Subject: FRONT SEAT RECLINER LEVER KNOB DIFFICULT TO USE	Bulletin No: 09-032/16
	Last Issued: 05/13/2016

Front seat (Driver side)

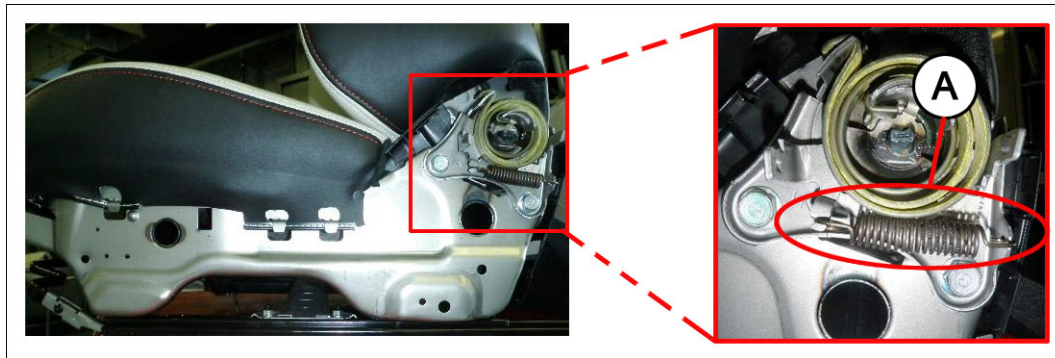
Some customers may complain about a front seat recliner lever knob difficult to move. This makes it difficult to change the seat back reclining position.

This may be caused by a return recliner lever knob spring (A) that is too strong.

Customers having this concern should have their vehicle repaired using the following repair procedure.
